ADDENDUM 1

August 5, 2025

**BLACK BROOK
GOLF COURSE
PARKING LOT
IMPROVEMENTS**

Contractor Submitted Questions

PROPOSED TRENCHING DETAIL
SCALE: NTS

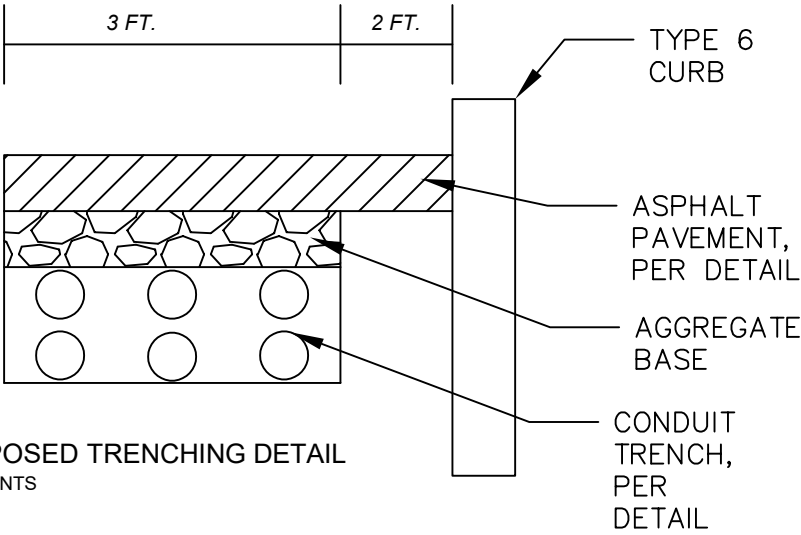
1. The existing east side of the parking lot edge is not a straight line. With the new Type 6 curb design on the edge, we would recommend sawcutting the existing asphalt edge and adding base paving an extra 5 feet as part of the trench repair for the primary electrical ditch.

A: Detail has been added to plan sheet C1. It would be an acceptable approach to the repairs. Trench repair would be included in pricing for line item 19 "4" Conduit."

TRENCH & BEDDING DETAILS (CITY OF MENTOR)

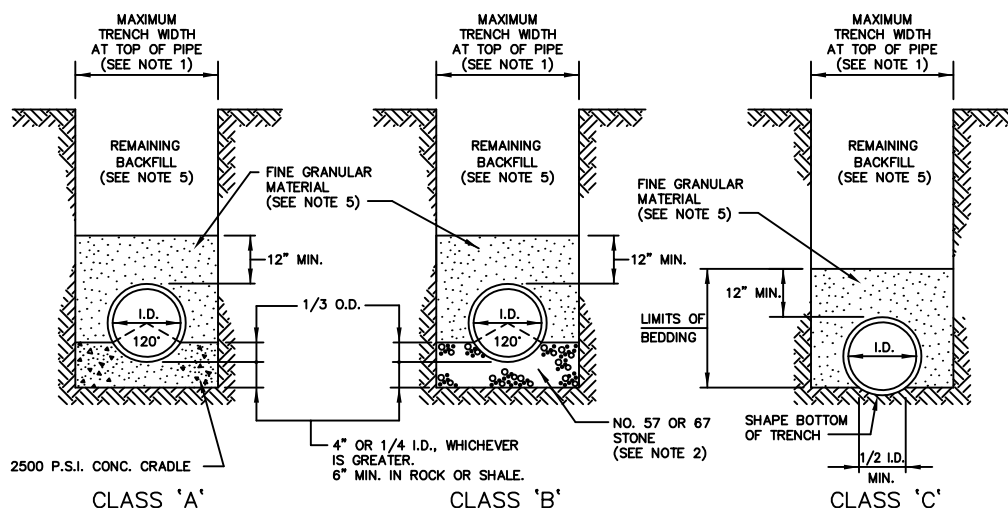
3. Is there an item for the repair of trenches for all the storm sewer work?

A: Repair of the trench should be included in the pricing for line item 14 "12" Conduit, Type B"
